Access Compliance Report

Public Rights-of-Way

Intersection ID: N/A	Main Street: MCKEE_RD	Cross Street: N/A	Location: NE
ADA ID: C5B1CE4BC076	Ramp Type: BlendTrans2	Initial Pass/Fail: Fail	Overall Compliance: No
		Severity Score: 10

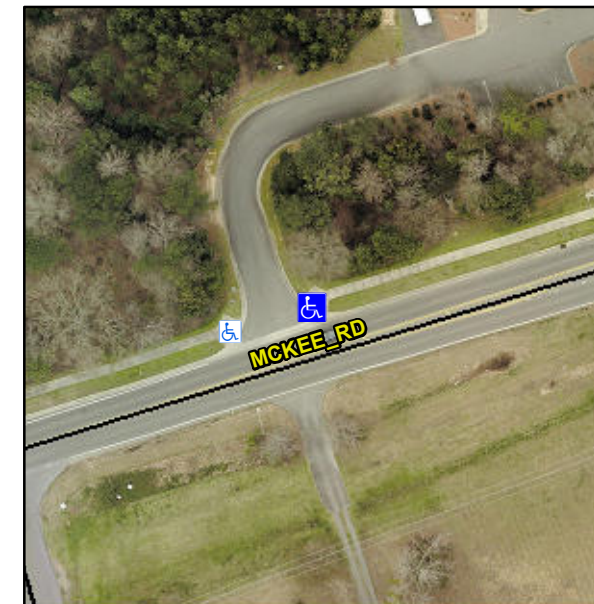
Not Found, R304.5.1, R304.5.3

Compliance	Description	Data	Compliance	Description	Data
N/A	Ramp Length (in)	122.0	Yes	BlendTrans Slope (%)	4.4
No	Ramp Width (in)	47.0	No	BlendTrans XSlope (%)	3.2
N/A	Flare Type LT	N/A	N/A	Flare Type RT	N/A
N/A	Flare Slope LT (%)	N/A	N/A	Flare Slope RT (%)	N/A
N/A	Flare Traversable LT?	N/A	N/A	Flare Traversable RT?	N/A
N/A	Landing Length (in)	N/A	N/A	DWS Provided?	N/A
N/A	Landing Width (in)	N/A	N/A	DWS Contrast?	N/A
N/A	Landing Slope (%)	N/A	N/A	DWS Length (in)	N/A
N/A	Landing X Slope (%)	N/A	N/A	DWS Full Width?	N/A
N/A	Landing Curb? (Y/N)	N/A	N/A	DWS Offset (in)	N/A
N/A	Shared Landing?	N/A			
N/A	Gutter Ponding?	N/A	N/A	Gutter Slope (%)	N/A
N/A	Gutter Lip Ht (in)	N/A	N/A	Gutter X Slope (%)	N/A
N/A	Painted X Walk1?	No	N/A	Painted X Walk2?	No
	X Walk 1 Direction	To W		X Walk 2 Direction	To S
	X Walk 1 Width (in)	N/A		X Walk 2 Width (in)	N/A
	X Walk 1 Slope (%)	0.2		X Walk 2 Slope (%)	4.0
	X Walk 1 X Slope (%)	1.2		X Walk 2 X Slope (%)	0.7

N/A	Ramp inside XWalk1?	N/A	N/A	Ramp inside XWalk2?	N/A
	Road Slope (%)	3.6		Clear Space?	N/A
	Road X Slope (%)	3.0	N/A	Clear Space to XWalk (in)	N/A
N/A	Any Obstructions?	N/A	N/A	Storm Grate/Utility Hazard?	N/A
	Obstruction Type			Storm Grate/Utility Type	
		N/A			N/A
			Yes	Surface Condition? (G/P)	Good
			No	Curb Slope (%)	11.1

Remove & Replace Curb Ramp With Two New Directional Ramps or Equivalent.
